**CLARIFICATION AGAINST PROC-FB/CB/PQ/WHA/D-4973/21** Pre-qualification of manufacturers / suppliers for all sizes of wellhead assemblies along with acces ..

OPTION 1:  
PIN THREAD ON  
WEAR BUSHING R.R.T. SIDE,  
BOX THREAD ON  
B.O.P. TEST PLUG SIDE.

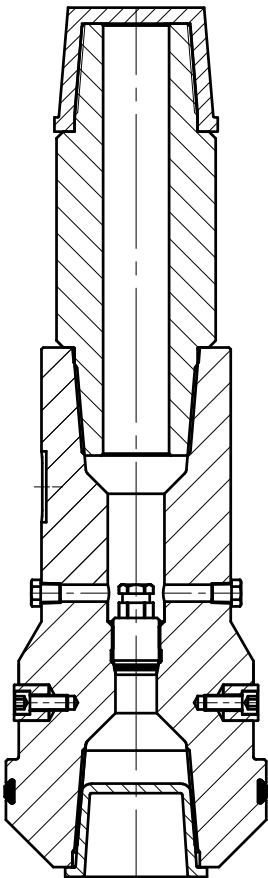
Clarification: **“In order to be sure of Customer requirement, we kindly ask to select the preferred option for combination tools threads on attached drawing”.**

OGDCL's Reply: Please note that Option-2 is required as per SOR (Schedule of requirement) i.e. BOX THREAD ON WEAR BUSHING R.R.T. SIDE AND PIN THREAD ON B.O.P. TEST PLUG SIDE (SEE ATTACH DRAWING).
